**Honorable City Planning Commission  
Cincinnati, Ohio**

**ITEM 6  
June 6, 2025**

**SUBJECT:** A report and recommendation on a proposed Notwithstanding Ordinance permitting a parking facility at 515 Water Street in the Central Business District.

DRAWING TITLE  
LOCATION PLAN

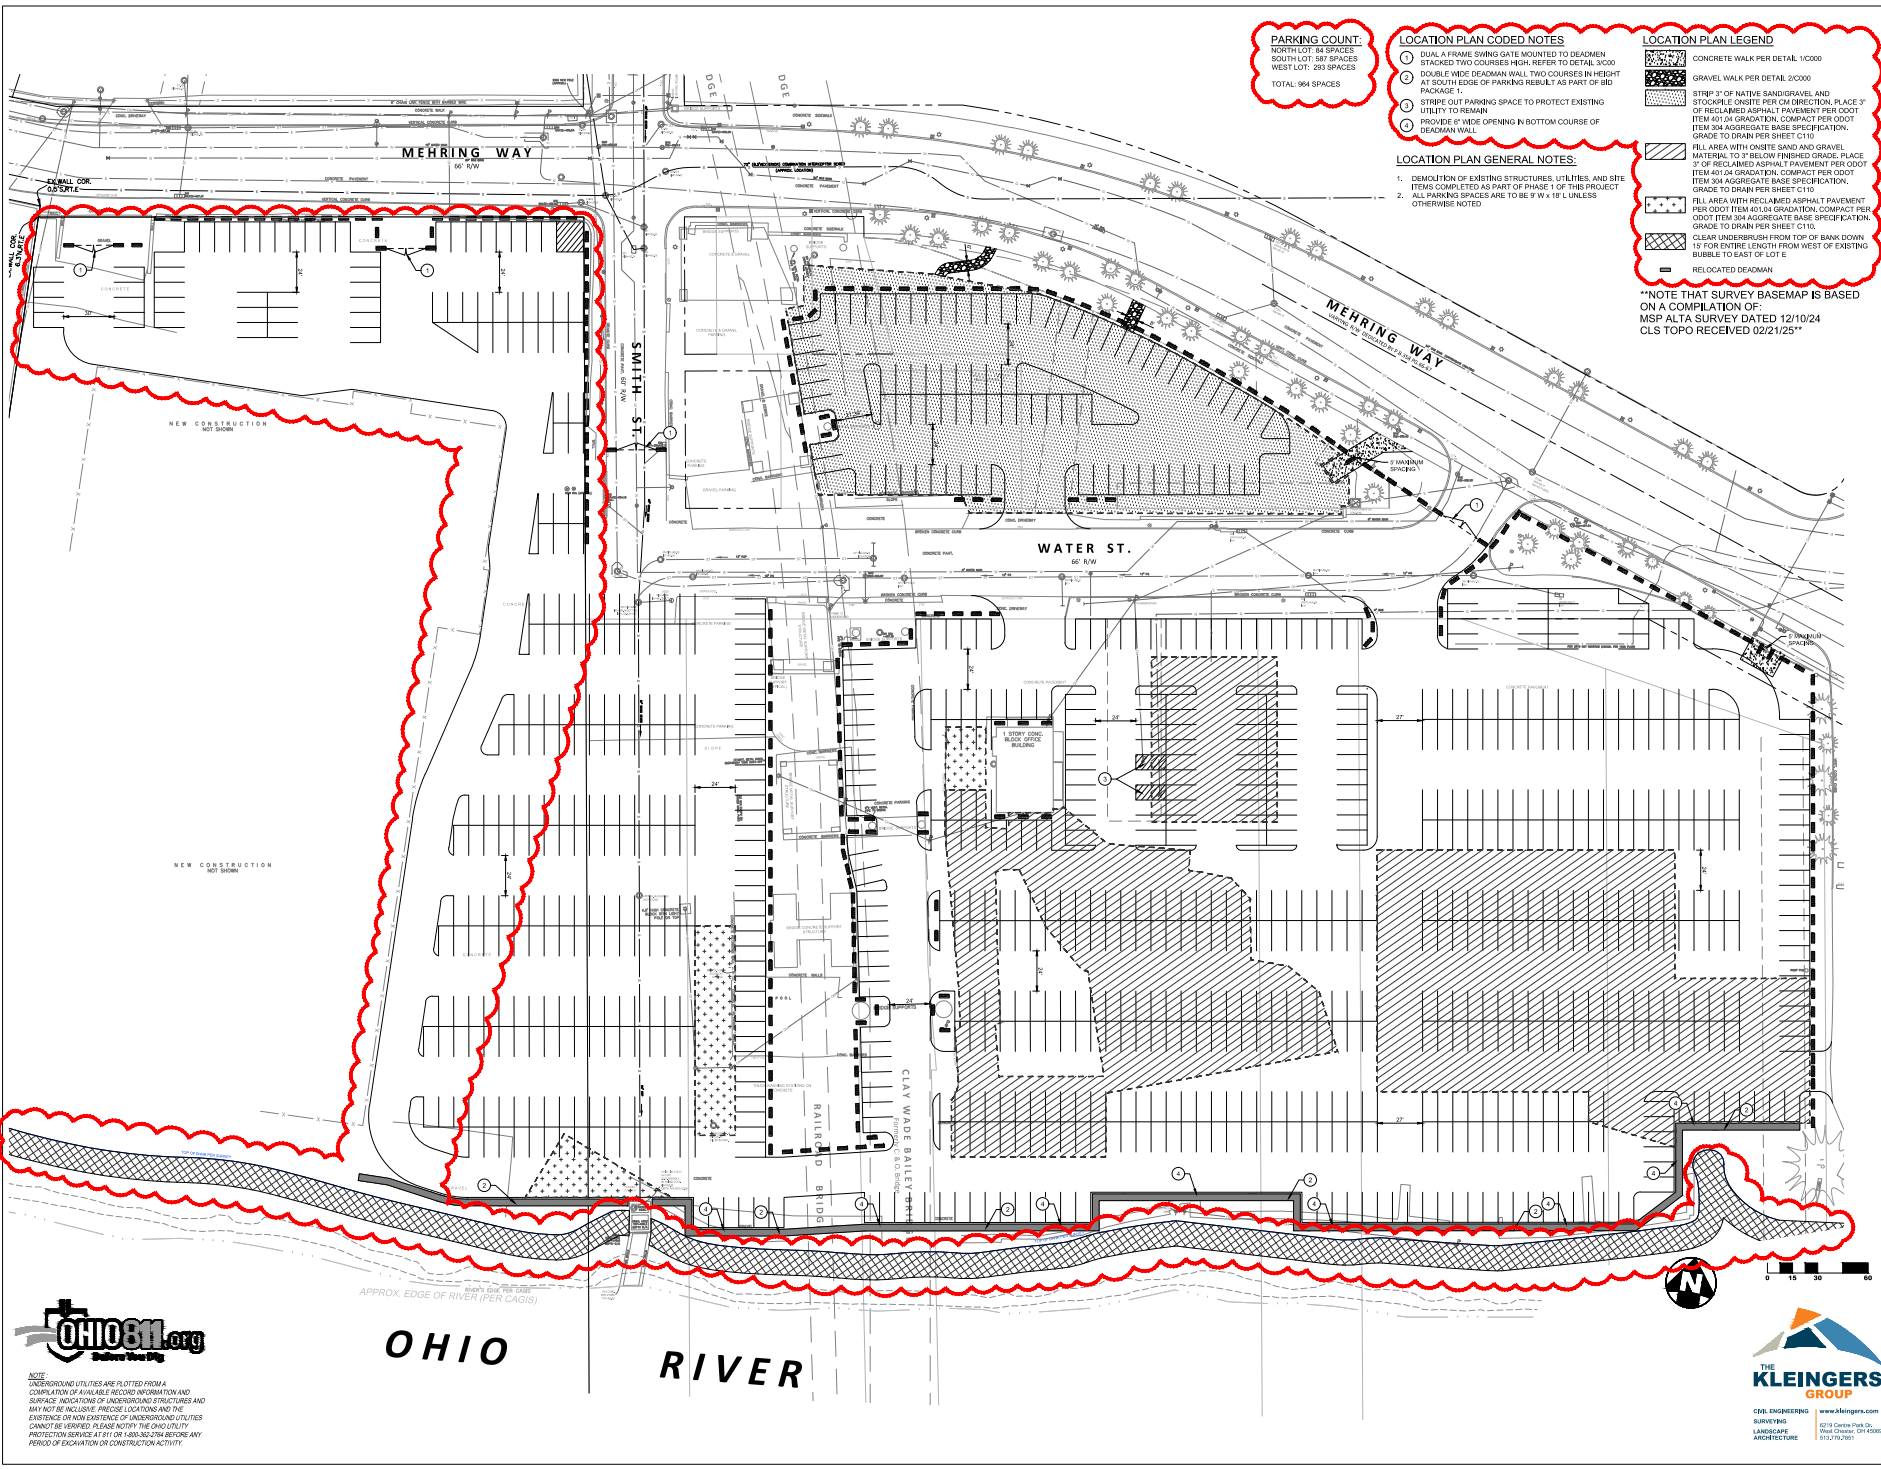
*Existing landscaping is not shown on the provided plans and there is not enough information to review compliance. Plans note "clear underbrush from top of bank down 15' for entire length from west of existing bubble to east of lot E" and "contractor to remove trees and clear areas as necessary" which appear inconsistent with this requirement. Please clarify on the site plan if any existing tree cover or vegetation is being removed from the pool stage of the Ohio River and line 50 ft. inland from and congruent with the Markland Dam pool stage.*

*Proposed light poles are 20'5" above grade but fixtures appear to be mounted no more than 20' above grade throughout the site. Please confirm this is correct and that the fixtures are energy efficient.*

*Please provide details of gates and deadman barricades for review.*

*Please provide details of curb cut width for review.*

*A Use Variance is required for the proposed use.*

**No Landscaping Plan has been provided.**

*A **Special Exception** for the proposed Parking Lot Landscaping is required.*

*No wheel stops are shown on the plans. A **Variance** is required to not provide wheel stops.*

5. **1425-37(b): Surfacing, Drainage and Grade of Parking and Loading Facilities.**  
**Surfacing.** Parking areas, maneuvering aisles and loading spaces must be paved with asphalt, concrete, interlocking masonry pavers or surfaced with open honeycomb paving blocks which allow grass or ground cover to grow, except as otherwise authorized by the Zoning Administrator.  
*Reclaimed asphalt pavement is proposed.*
